City of Detroit
Inter-Departmental Communication

RE: Petition No. 126
Request Outright Vacation Public Of The East/West Public Alley In The Area
Bound By Outer Drive, Hartwell, Santa Maria, And Schaefer Highway

NOTICE OF PROPOSED CHANGE IN PROPERTY

B						REQUEST TO OUTRIGHT VACATE PART OF THE EAST/WEST PUBLIC ALLEY, 16 FT.WD IN THE BLOCK BOUND BY SCHAEFER HIGHWAY, OUTER DR., HARTWELL AVE. AND SANTA MARIA AVE. ABUTTING LOTS 1, 2 AND 6	CITY OF DETROIT CITY ENGINEERING DEPARTMENT SURVEY BUREAU
	A						
DESCRIPTION		DRWN	CHKD	APPD	DATE	JOB NO. 01-01	
DRAWN BY SA		CHECKED KSM			DATE 03-11-19		DRWG.NO. X 126
REVISIONS							
APPROVED

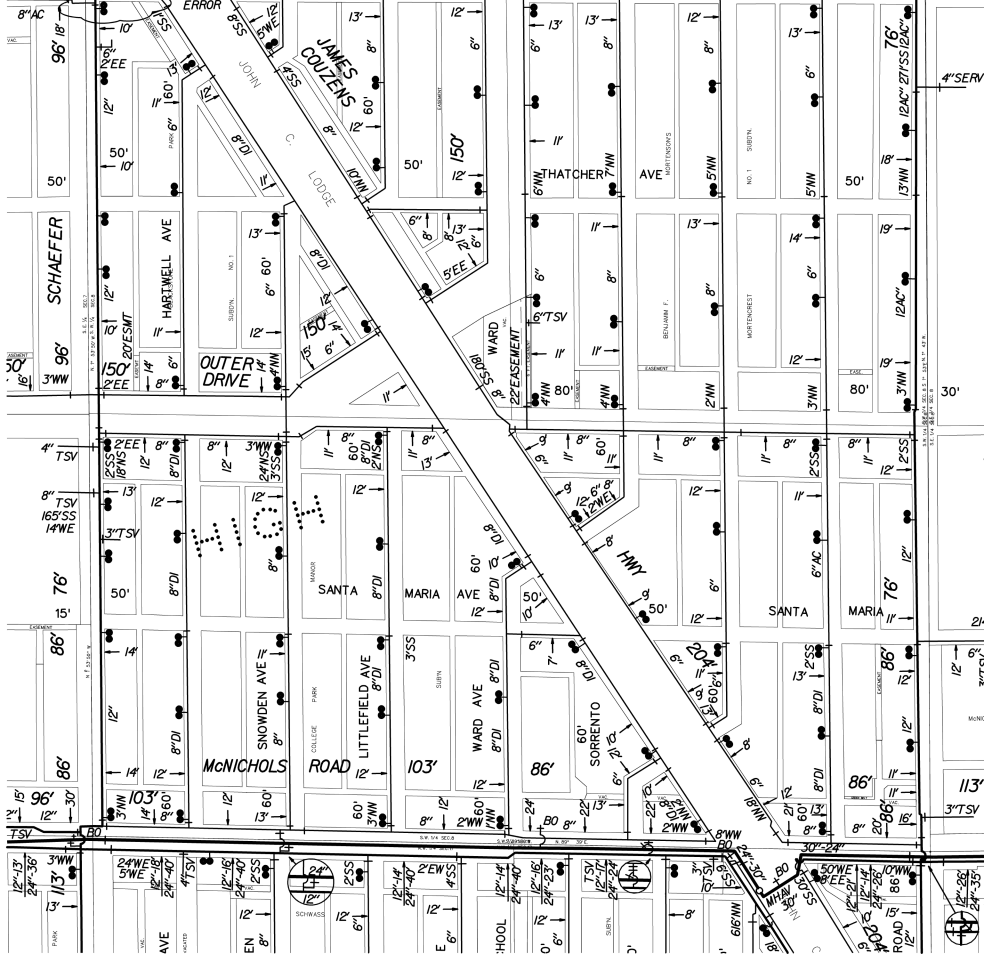
The Detroit Water and Sewerage Department (DWSD) is in receipt of the subject petition. There is a sewer located in the alley requested for vacation. DWSD has no objection to the requested vacation provided that the following conditions are met:

- The sewer services no other properties and only service the properties owned by the Petitioner, if not the Petitioner must prepare a relocation plan for the sewer signed by a Registered Engineer, DWSD approves the relocation plans, and the Petitioner grants a satisfactory easement for the relocated sewer. The Petitioner is to bear the entire cost of the proposed relocation plans, including construction, demolition, permitting, inspection, survey, etc.
- If DWSD is to maintain ownership of the existing sewer a satisfactory easement must be granted by the Petitioner.

The entire work is to be performed in accordance with DWSD specifications and standards, all of the fees are to be deposited with DWSD in advance, to cover the necessary costs of permits and inspection.

Detroit Water & Sewerage Department
Provisions for Relocation Due to Vacation for Petition No. 126

Provided that the petitioner shall design and construct proposed sewers and to make the connections to the existing public sewers as required by the Detroit Water and Sewerage Department (DWSD) prior to construction of the proposed sewers,

Provided that the plans for the sewers shall be prepared by a registered engineer; and further

Provided that DWSD be and is hereby authorized to review the drawings for the proposed sewers and to issue permits for the construction of the sewers, and further

Provided that the entire work is to be performed in accordance with plans and specifications approved by DWSD and constructed under the inspection and approval of DWSD; and further

Provided that the entire cost of the proposed sewers construction, including inspection, survey and engineering shall be borne by the petitioner; and further

Provided that the petitioner shall deposit with DWSD, in advance of engineering, inspection and survey, such amounts as the department deems necessary to cover the costs of these services; and further

Provided that the petitioner shall grant to the City a satisfactory easement for the sewers; and further

Provided that the Board of Water Commissioners shall accept and execute the easement grant on behalf of the City; and further

Provided, that the petitioner shall provide DWSD with as -built drawings on the proposed sewers; and further

Provided that the petitioner shall provide a one (1) year warranty for the proposed sewers; and further

Provided that upon satisfactory completion, the sewers shall become City property and become part of the City system. And any existing sewers that were abandoned shall belong to the petitioner and will no longer be the responsibility of the City.
